UNITED STATES ENVIRONMENTAL PROTECTION AGENCY
REGION IX
75 Hawthorne Street
San Francisco, CA 94105-3901

Re: Technical Evaluation Comments and Information Request of CES's Responses to
EPA's Initial Technical Evaluation Comments and Information Requests #1-4
CES-Mendota Site Underground Injection Control (UIC) Permit Application
Class VI Pre-Construction Permit Application No. R9UIC-CA6-FY20-1

Evaluation of Applicant Responses to EPA's Technical Review Comments on the Geologic Information in the CES-Mendota Class VI Permit Application

Figure 7. Upscaled porosity profile along the N-S cross-section.

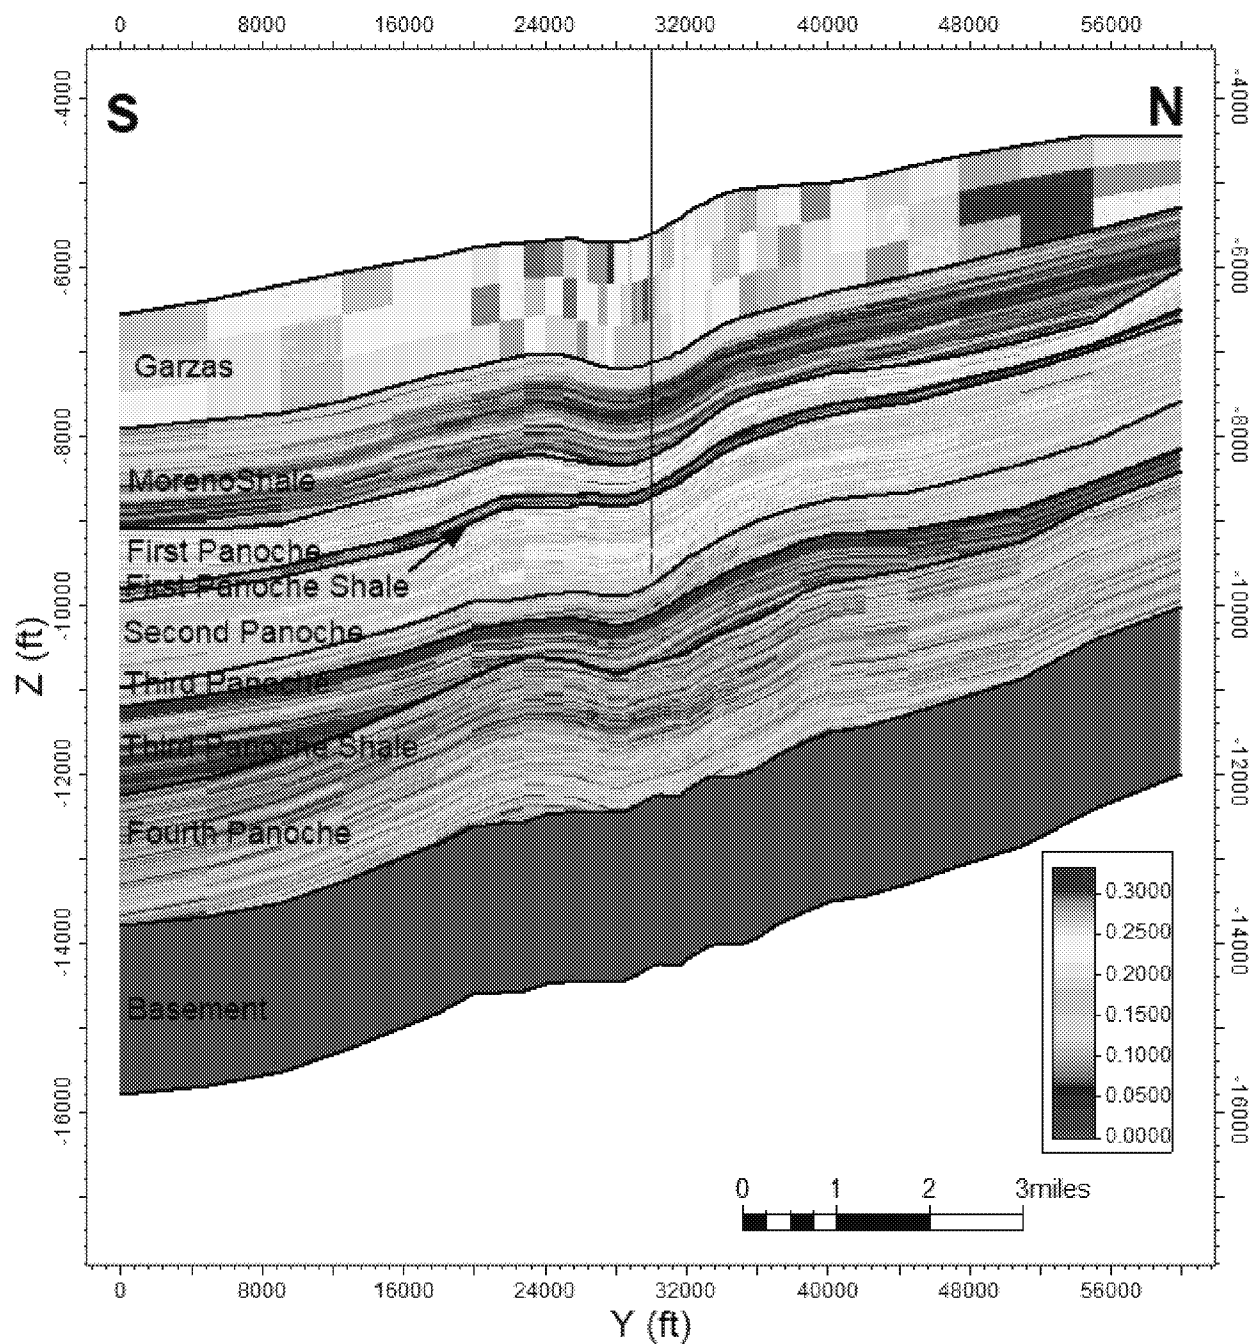
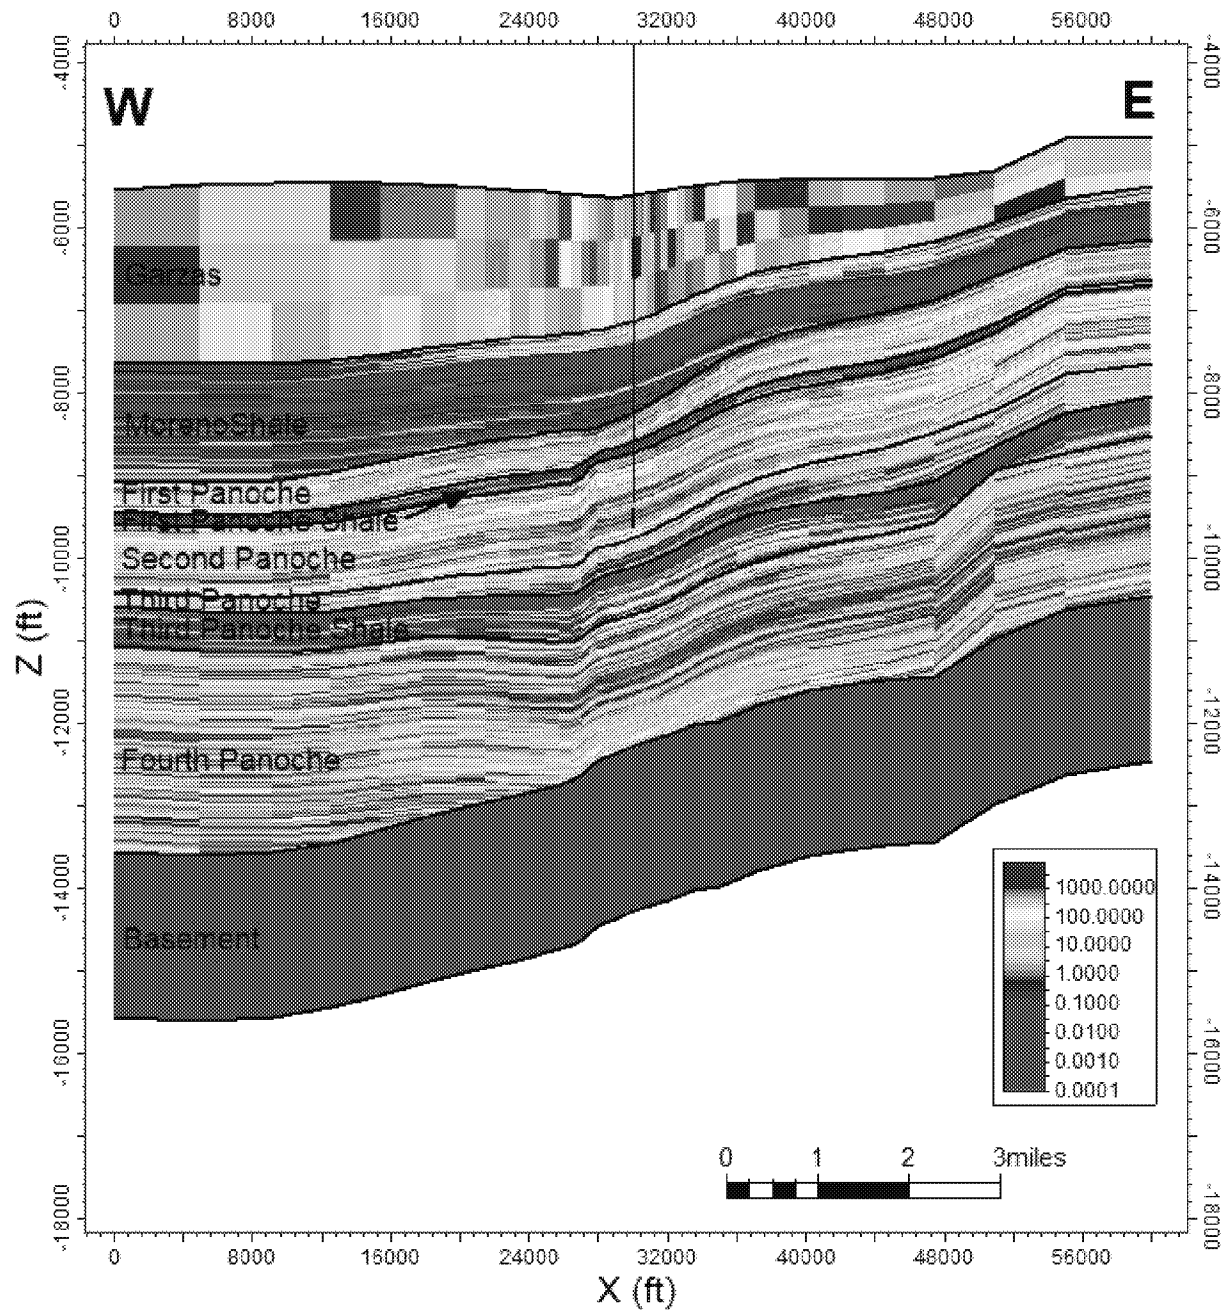
2.3.1	"The upscaled porosity and permeability graphics in Attachment B (Figures 3 and 4) would benefit from labeling for formation tops."	<i>The figures were updated with formation tops in Figure 7 and Figure 8 (refer to Appendix A).</i>

Figure 14: BB Co. 1 wellbore after P&A operation

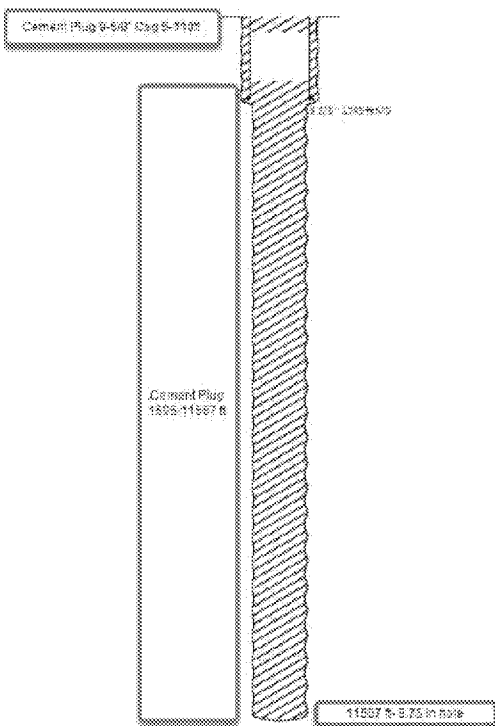
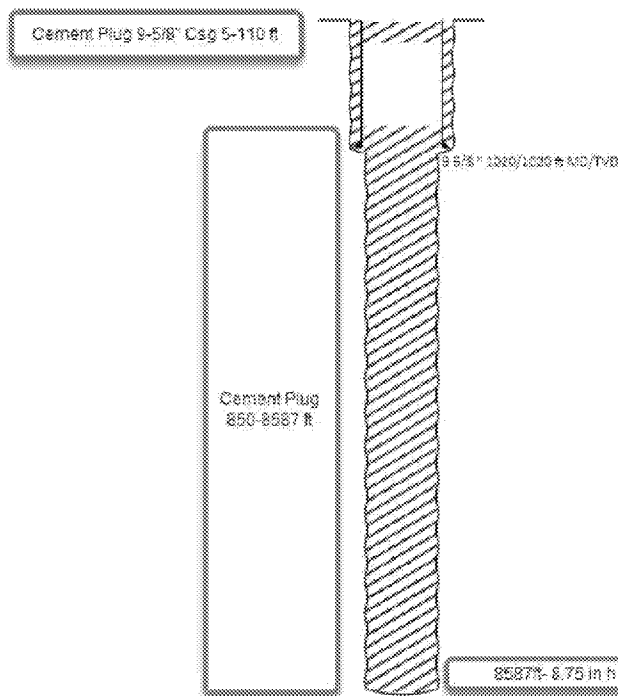
- *The plugging procedures for Amstar 1 and BB Co 1 on pages 25 and 26 reference a casing diameter of 9 5/8 inches; however, figures 14 and 15 show that the hole is 8.75 inches. Please clarify the discrepancy.*
- *This is correct. The 9 5/8-in. surface casing has drift inner diameter of 8.75 in. Therefore, an 8.75-in. hole was drilled below the 9 5/8-in. casing.*
